Access Compliance Report

Public Rights-of-Way

Intersection ID: 27277	Main Street: BALLANTYNE COMMONS PY	Cross Street: ESSEX FELS DR	Location: NE
ADA ID: 40B41A499715	Ramp Type: PerpDiag	Initial Pass/Fail: Fail	Overall Compliance: No
Severity Score: 10			
Codes/Mitigation Info/Possible Solution		Field Measurements/Component Compliance

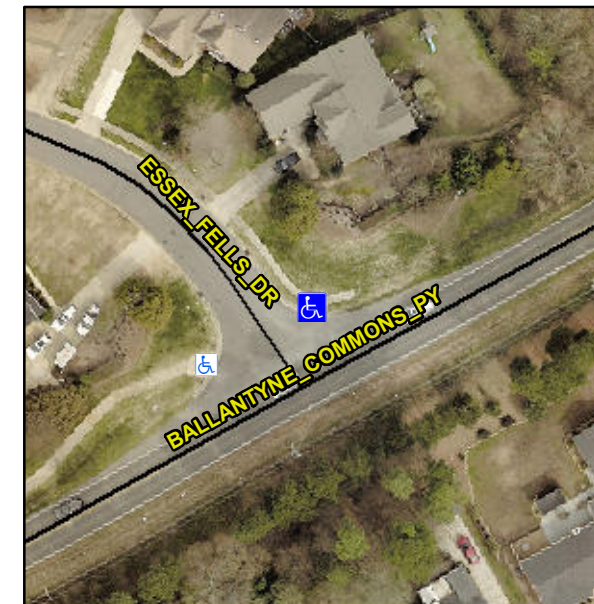
Not Found, R304.5.1, R304.5.3

Compliance	Description	Data	Compliance	Description	Data
N/A	Ramp Length (in)	48.0	Yes	Ramp Slope (%)	6.6
No	Ramp Width (in)	46.5	No	Ramp XSlope (%)	3.5
N/A	Flare Type LT	N/A	N/A	Flare Type RT	N/A
N/A	Flare Slope LT (%)	N/A	N/A	Flare Slope RT (%)	N/A
N/A	Flare Traversable LT?	N/A	N/A	Flare Traversable RT?	N/A
N/A	Landing Length (in)	N/A	N/A	DWS Provided?	N/A
N/A	Landing Width (in)	N/A	N/A	DWS Contrast?	N/A
N/A	Landing Slope (%)	N/A	N/A	DWS Length (in)	N/A
N/A	Landing X Slope (%)	N/A	N/A	DWS Full Width?	N/A
N/A	Landing Curb? (Y/N)	N/A	N/A	DWS Offset (in)	N/A
N/A	Shared Landing?	N/A			
N/A	Gutter Ponding?	N/A	N/A	Gutter Slope (%)	N/A
N/A	Gutter Lip Ht (in)	N/A	N/A	Gutter X Slope (%)	N/A
N/A	Painted X Walk1?	No	N/A	Painted X Walk2?	No
	X Walk 1 Direction	To SW		X Walk 2 Direction	To S
N/A	X Walk 1 Width (in)	N/A	N/A	X Walk 2 Width (in)	N/A
	X Walk 1 Slope (%)	1.5		X Walk 2 Slope (%)	1.8
	X Walk 1 X Slope (%)	1.8		X Walk 2 X Slope (%)	1.0

Remove & Replace Curb Ramp With Two New Directional Ramps or Equivalent.
